SUBJECT: Fuel Tank Assembly

DATE: 1/1/65

UNITS AFFECTED: XL Engines

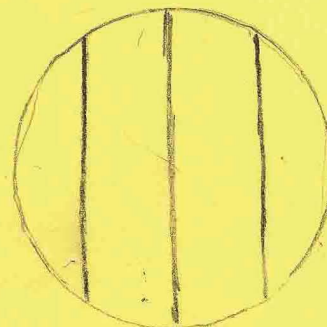
The felt washer, P/N 59457 is now used in all XL tanks.The rubber gasket, P/N 58865 should be installed between the round felt washer and the large aluminum washer as shown.

Please mark your parts books to show the correct sequence of assembly.

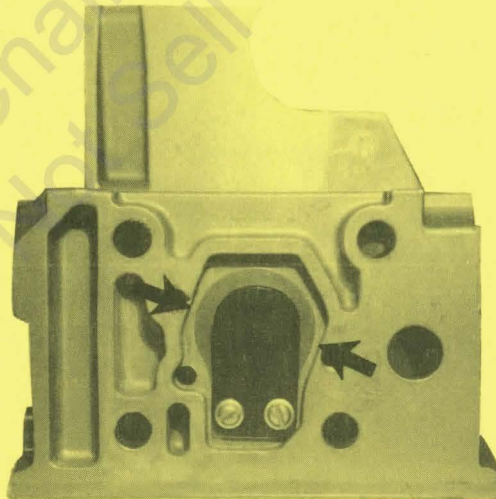
When you replace any of the reeds which are secured with screws, great care should be taken to get the reed centered over the opening.

Align XL reeds so that the spaces between the edge of the reed and the two screw holes are identical (see arrows in sketch). Failure to align reeds invites breakage! Also, use Loctite on the reed screws to keep them from working loose.

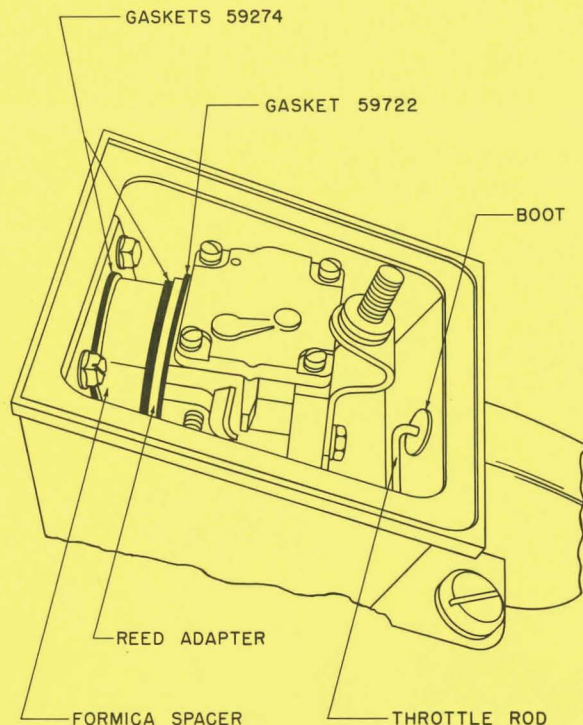
Two of these 1/32" thick gaskets are used between the formica spacer and the reed adapter (see arrow in sketch), and one 1/32" thick gasket is used between the formica spacer and the carburetor chamber.

The gaskets we now use -- and all P/N 59274 gaskets from Service Parts Stock -- are 3/64" thick.

If you service one of the saws with three P/N 59274 gaskets, please discard all three gaskets and replace with two (one on each side of the formica spacer) P/N 59274 - 3/64" thick gaskets from stock.

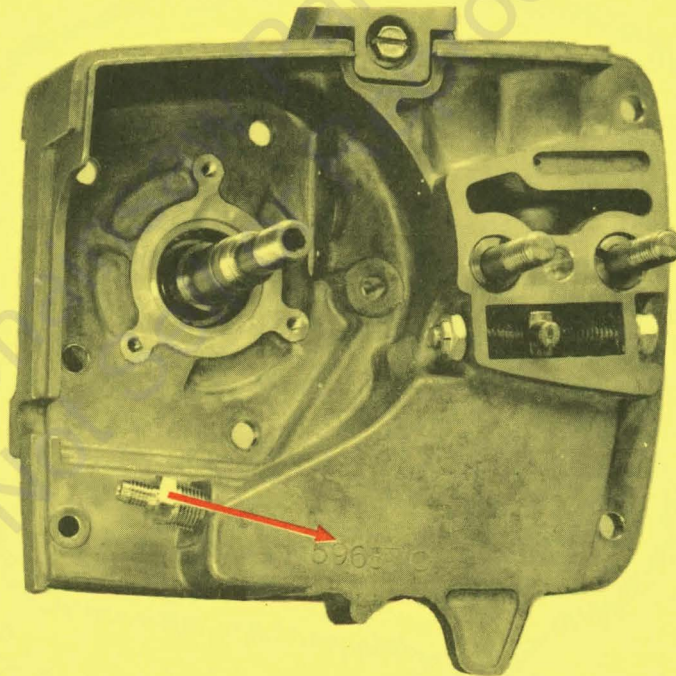
We snapped the picture below to show the angle at which the Oil-Pick-Up assembles into the drive case.

Some people have "cross threaded" these fittings by trying to install them parallel to the floor - which is not correct.

This picture should help you to remember to "angle" the part slightly so that it goes in properly and seals tightly.

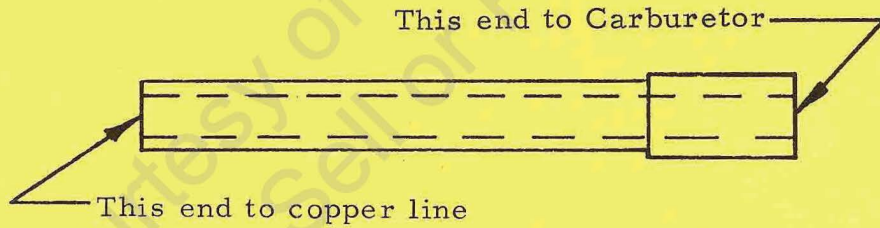
A new, Molded Fuel Line, Part No. 58958, is now used in the units listed above.

58997	}	Use up; ask for Part No. 58958 next order.
59828

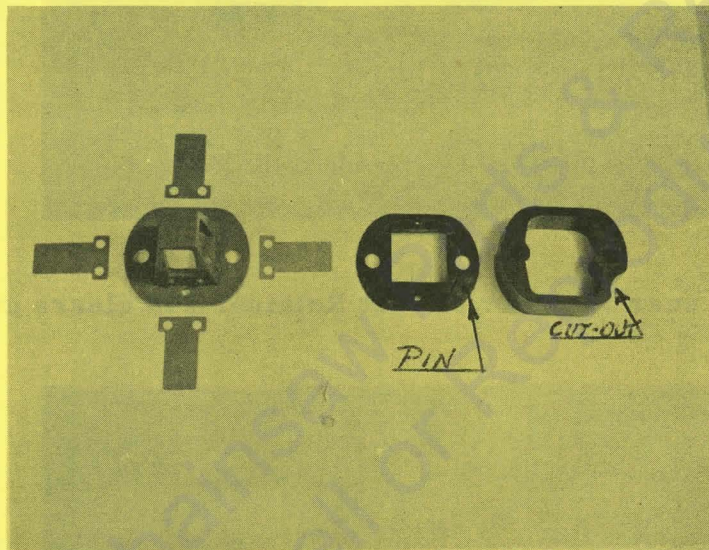
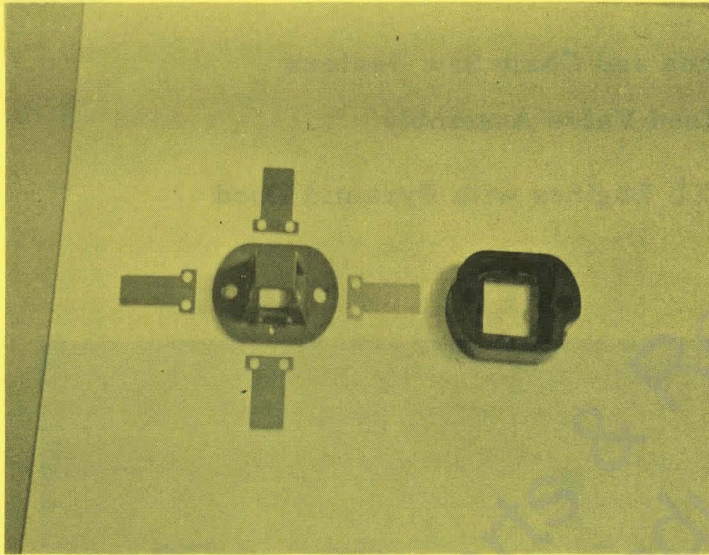
The picture above shows the new molded Delrin Reed Valve Seat, Part No. 63253 (on the left, among the four reeds). You'll note that there are no more screws and no more springs.

Instead, all four reeds are retained by a new molded rubber Reed Valve Retainer, Part No. 63260 (the center piece with the little "Pin").

1

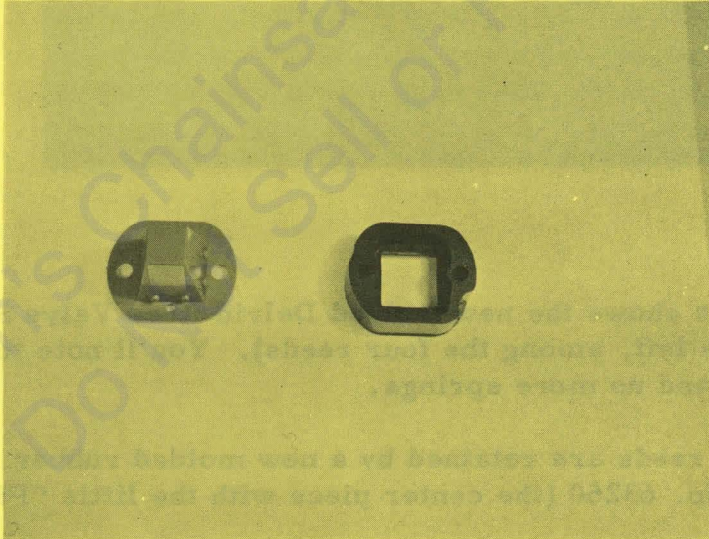
Place Spacer over Retainer so that Retainer Pin clears cut-out.

2

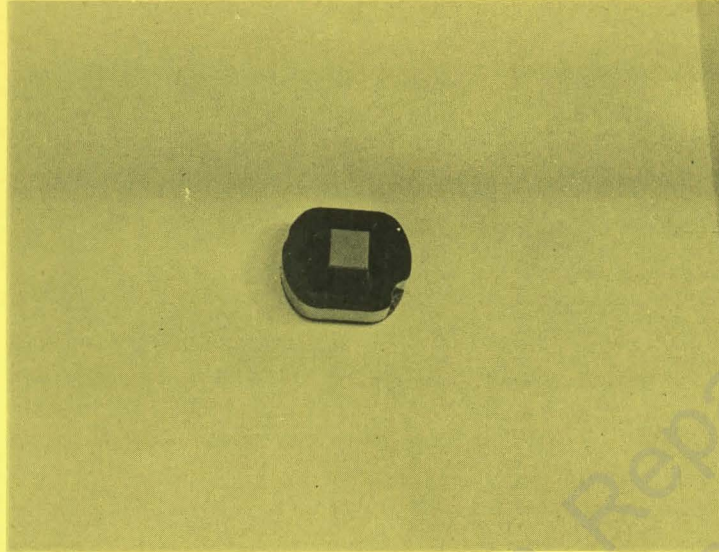
Place all four Reeds onto Reed Seat Posts.

3

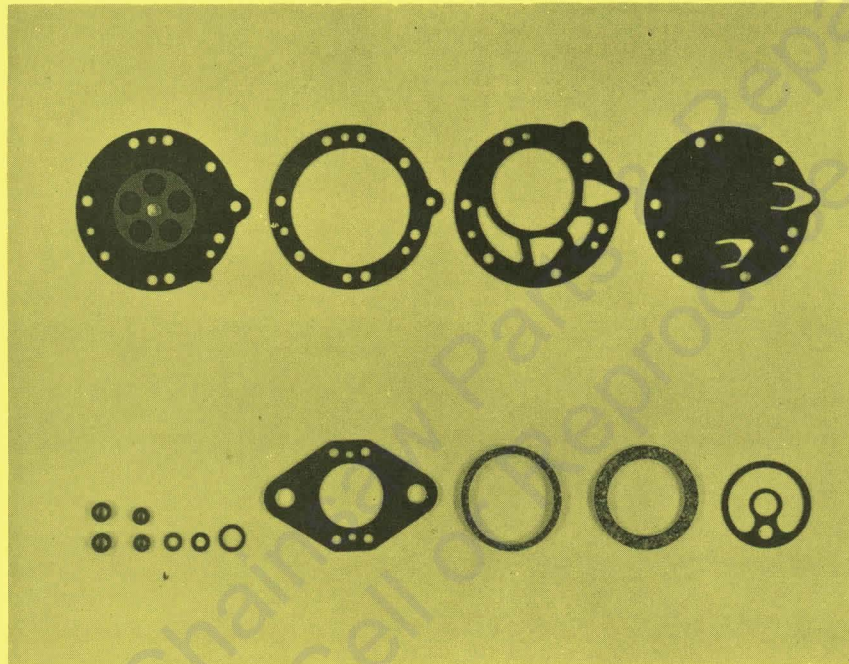
Slide Retainer/Spacer Assembly over the Reeds to lock all parts together.
